<b>STANDARD ROAD PLAN</b>	REVISION		
	<table border="1" style="width: 100%; border-collapse: collapse;"> <tr> <td style="width: 10px; text-align: center;">1</td> <td style="width: 50px; text-align: center;">04-21-15</td> </tr> </table>	1	04-21-15
	1	04-21-15	
<b>PV-106</b> SHEET 1 of 2

PCC RAILROAD  
 APPROACH SECTION

TYPICAL HALF PLAN  
SKEWED CROSSING  
(Symmetrical about centerline of tracks)

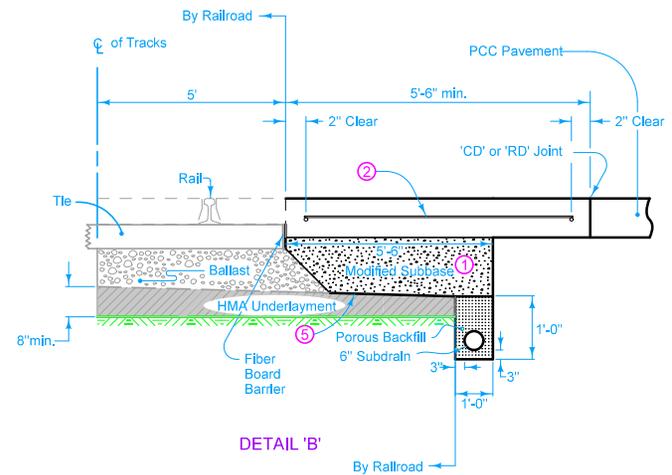
REVISIONS: Changed subdrain for skewed crossings to match skew.
